McCALL AREA PLANNING AND ZONING COMMISSION

Agenda

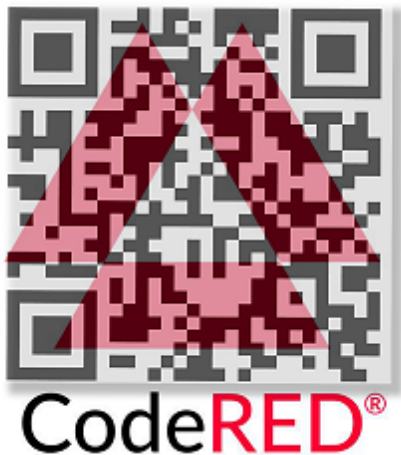
1. A fire hydrant will need to be added in the area of the first intersection within the development.
2. The multi-family units will likely need to have automatic fire sprinklers installed as determined by the building official during building plan review.
3. Knox Boxes will be required on any buildings with fire protection systems.

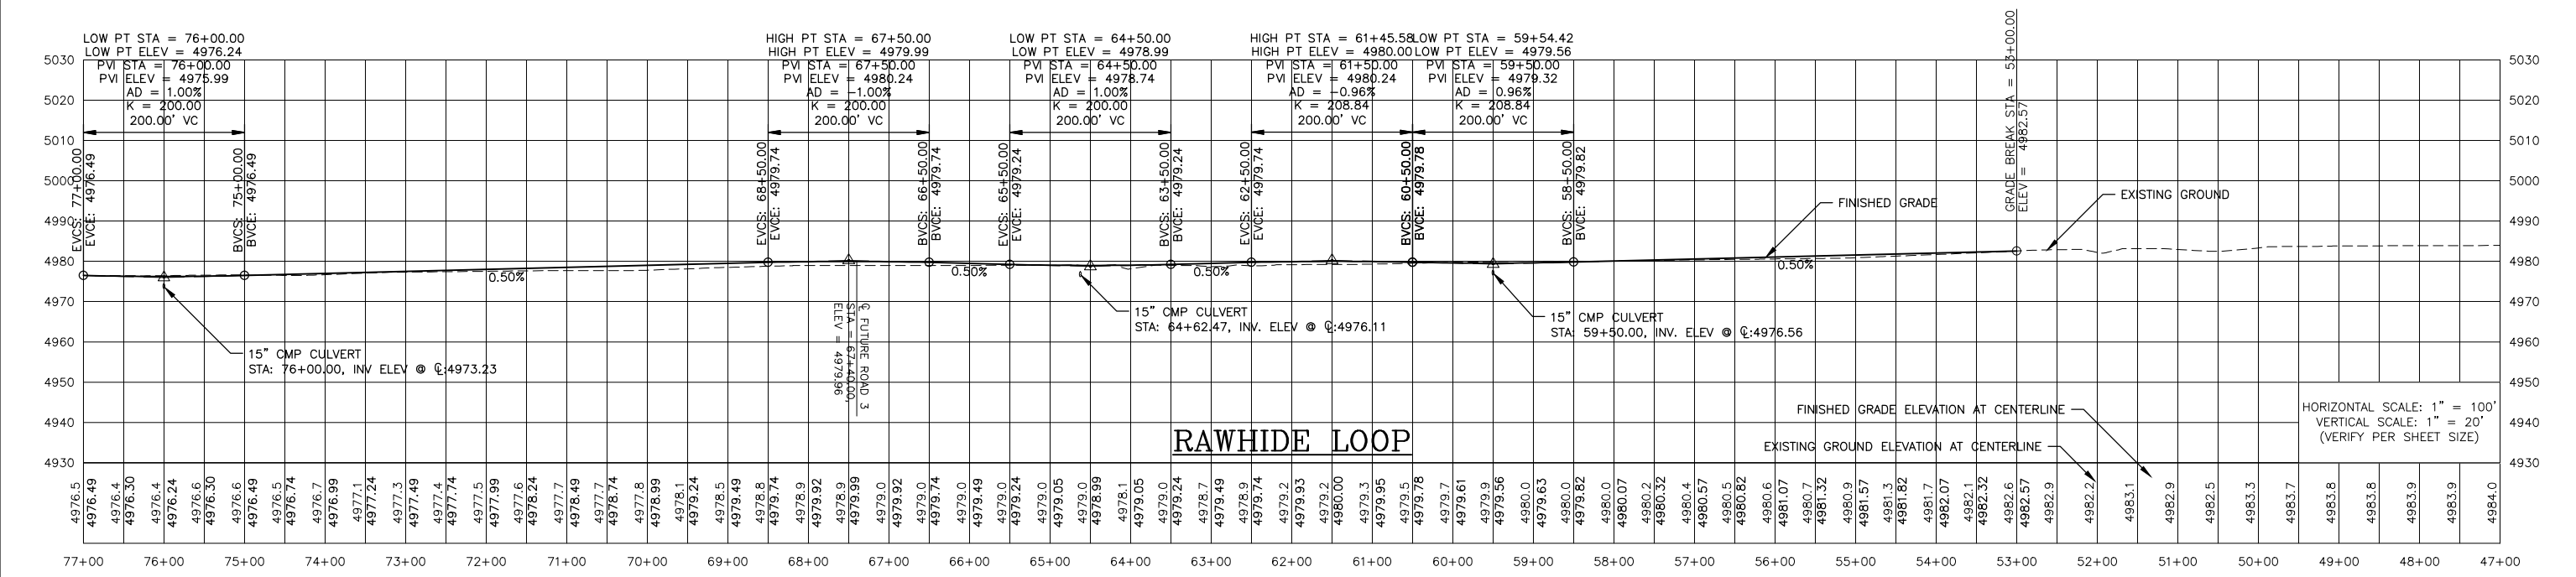
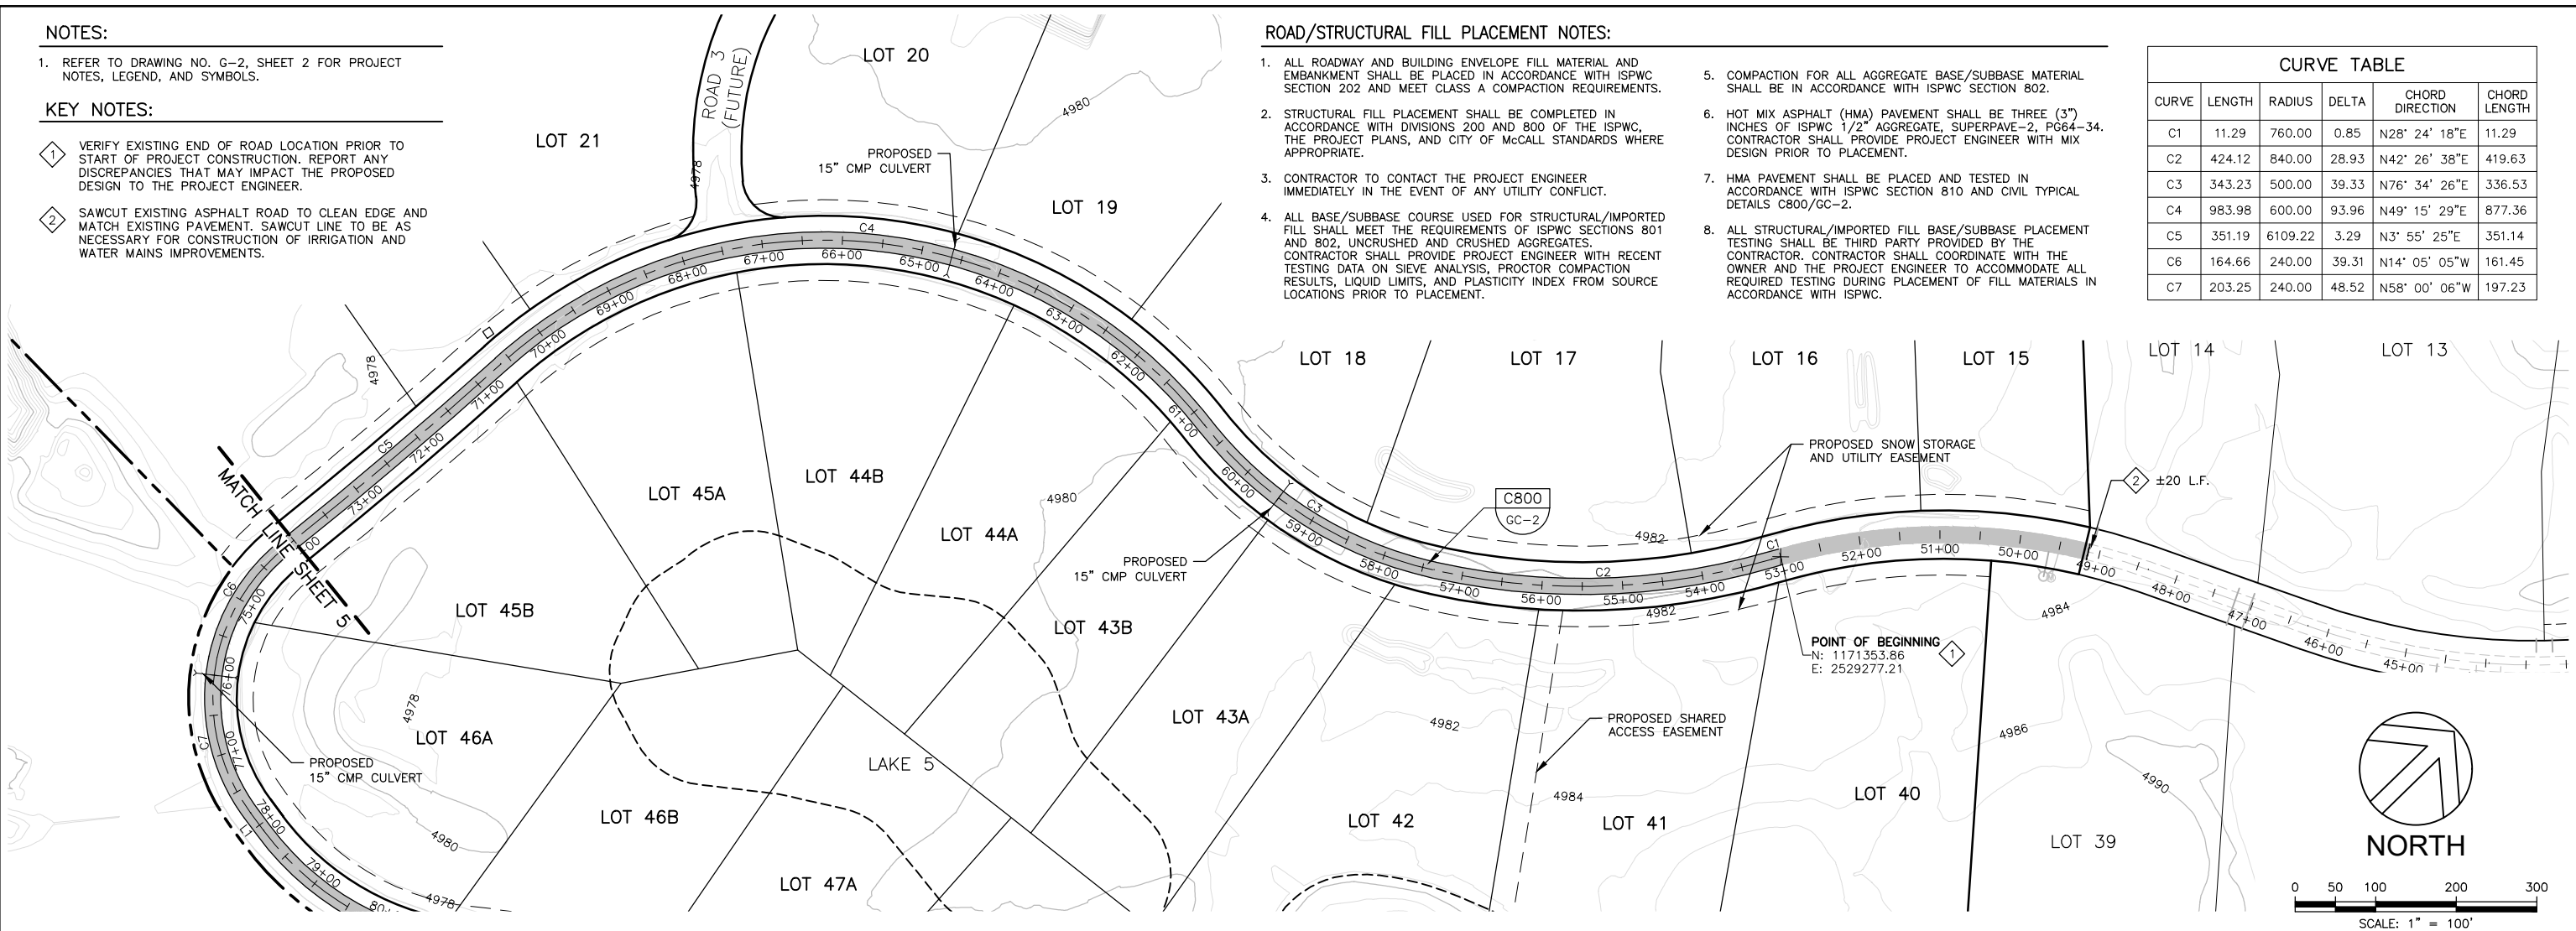
NO.	REVISION	BY	DATE	DESIGN
1.	CITY OF McCALL ENGINEERING SUBMITTAL	AMD	8/10/2022	AMD/GTT
2.	REVISED PER CITY OF McCALL COMMENTS	AMD	9/16/2022	DRAWN
3.	REVISED ROAD BASE/SUBBASE NOTE	AMD	10/13/2022	AMD

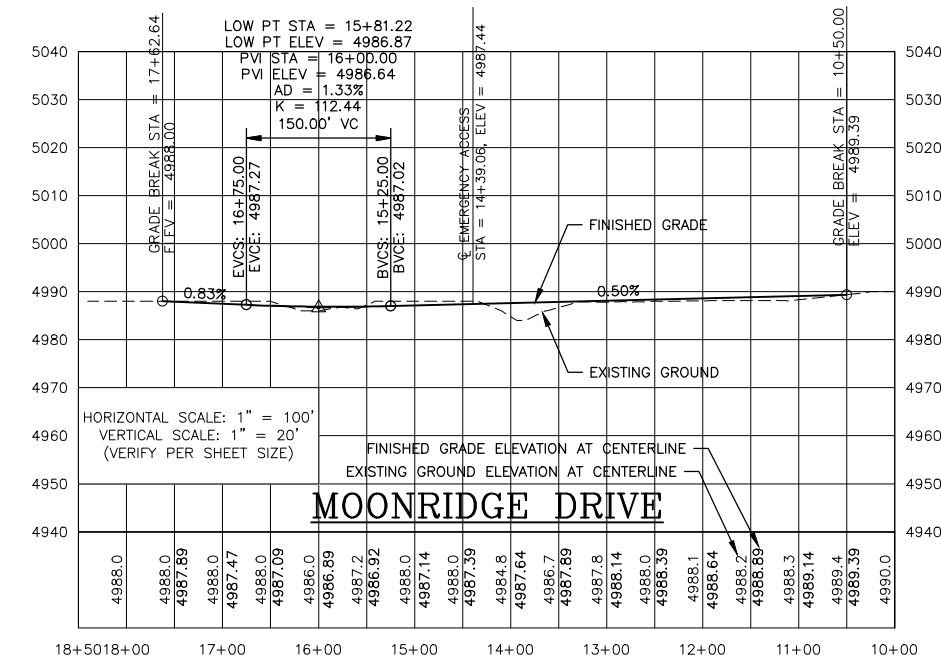
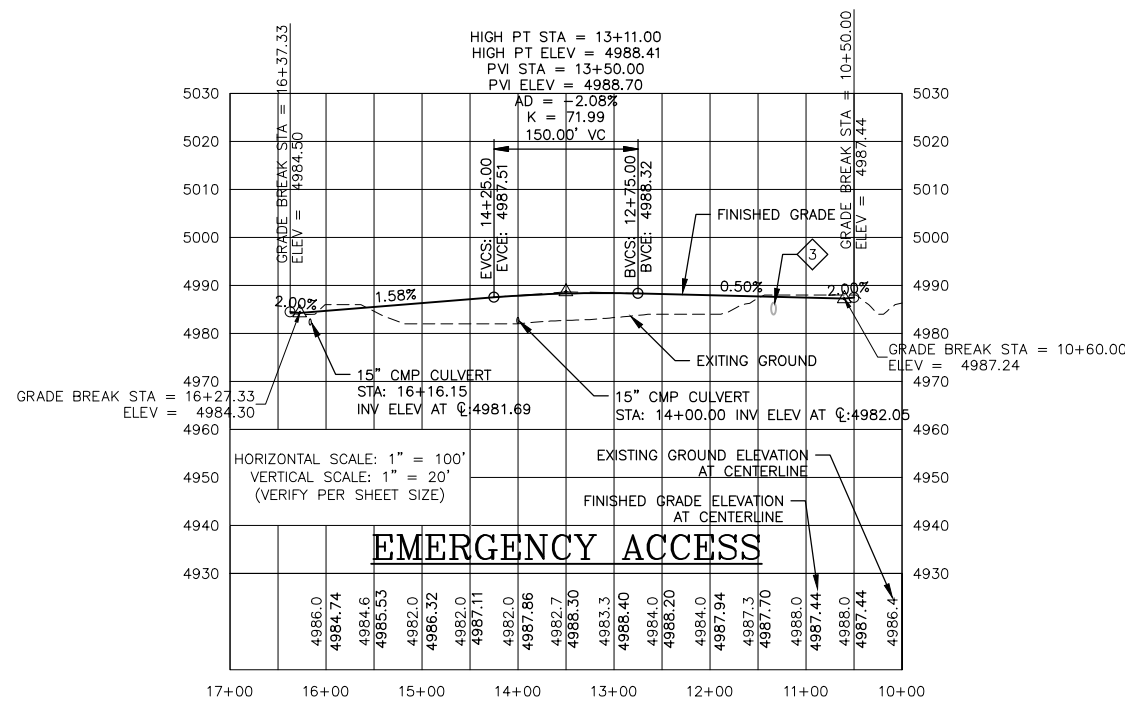
NO.	REVISION	BY	DATE	DESIGN
1.	CITY OF McCall ENGINEERING SUBMITTAL	AMD	8/10/2022	AMD/GTT
2.	REVISED PER CITY OF McCall COMMENTS	AMD	9/16/2022	DRAWN
				AMD
				CHECKED
				BEJ
				APPROVED
				GTT

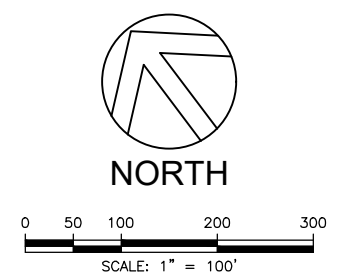
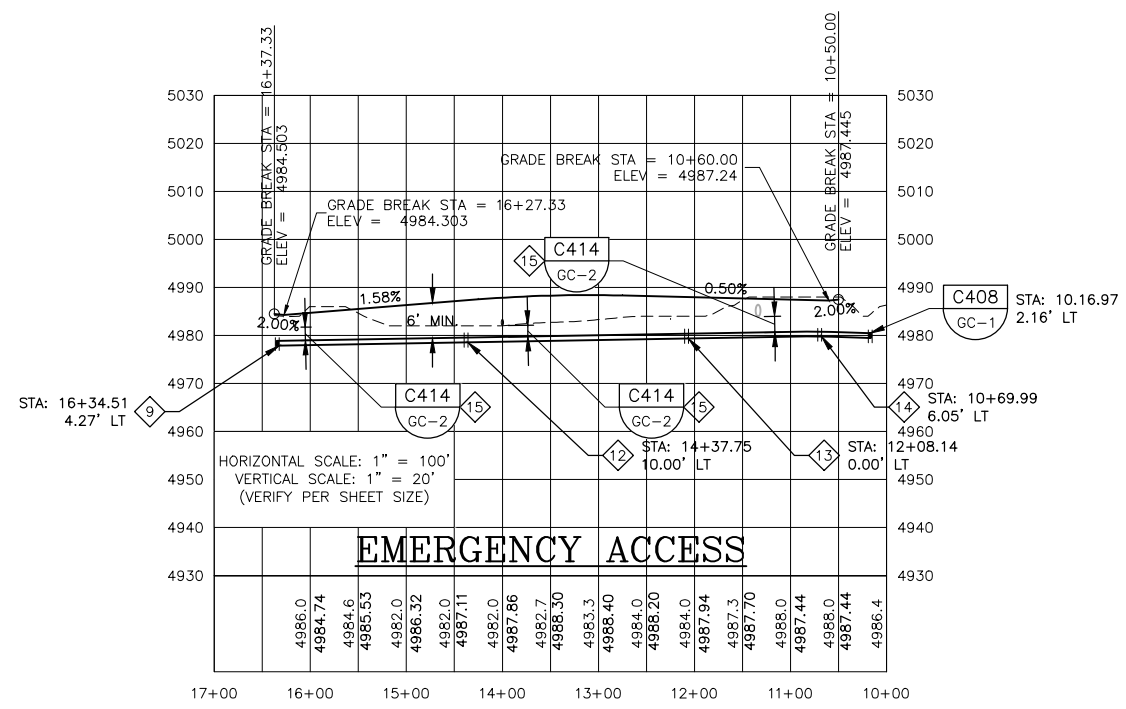
NO.	REVISION	BY	DATE	DESIGN
1.	CITY OF McCALL ENGINEERING SUBMITTAL	AMD	8/10/2022	AMD/GTT
2.	REVISED PER CITY OF McCALL COMMENTS	AMD	9/16/2022	DRAWN
				AMD
				CHECKED
				BEJ
				APPROVED
				GTT
